BULLETIN DE SERVICE

N° 101-29

PLANEURS SN CENTRAIR
101 tous types "Pégase"

OBJECT: VERIFY CONSTRUCTION OF THE PEDALS ADJUSTMENT LOCKING TUBE

Photo N° 1

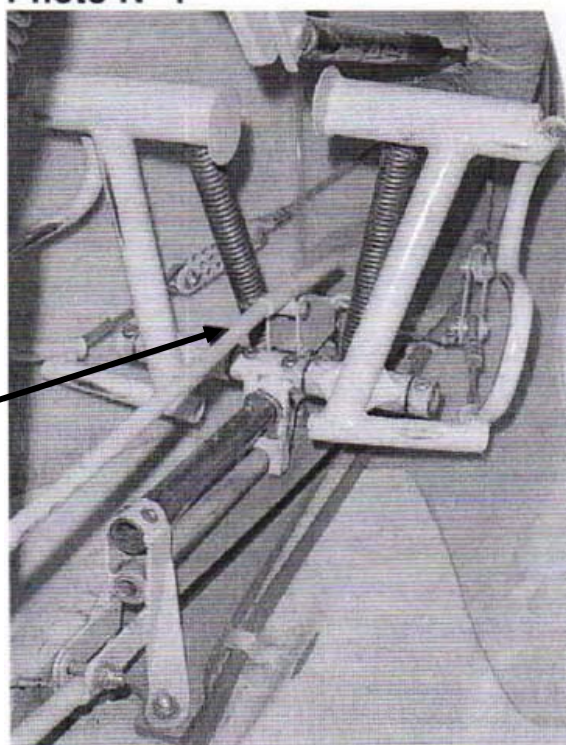
The adjustment system of the pedals consists of an articulating tube on a swing to unlock the pedals and ensure distance adjustment according to the figure of the pilot (see photo No. 1)

Articulating tube to
unlock the pedals

Photo N°2

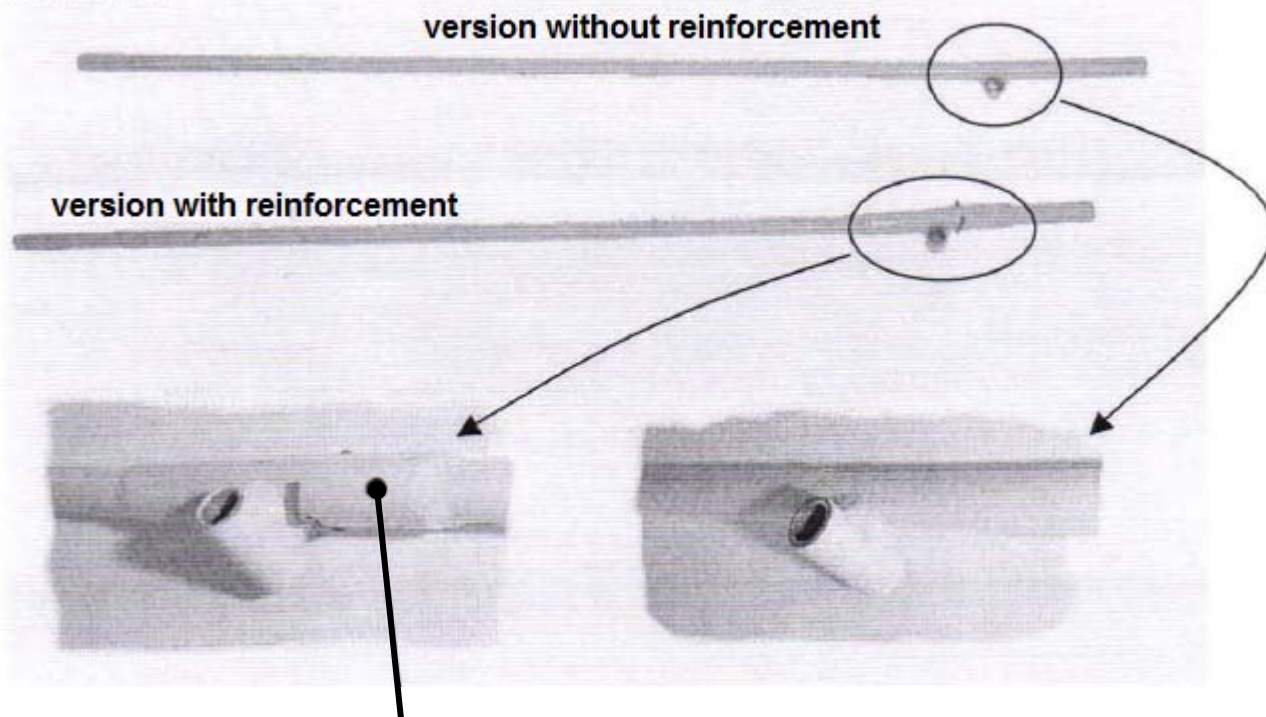
The articulating tube was strengthened in 1984 to avoid possible operational matters. The gliders manufactured before this evolution weren't systematically retrofitted.

The differences between the 2 versions are explained in the picture No. 2 here after.

Presence of a reinforced tube at the height of the pivot point for the enhanced version

Having recently been informed of the rupture of such an old type of articulating tube, it is confirmed that the reinforcement of this piece was justified and the systematic replacement of this old, non reinforced version, is necessary.

It is therefore requested, within 1 month, to check the version of adjustment tube which is installed in your glider (visual inspection without removal of parts of the glider).

In case of a reinforced tube version (e.g. photo No. 2) you don't have to perform supplemental actions.

If finding a non-reinforced tube version (e.g. photo No. 2), it is asked, before the next annual inspection, to perform a replacement by part ref. \$ Y186A. In case of observing damage on the locking tube the replacement must be done before next flight.
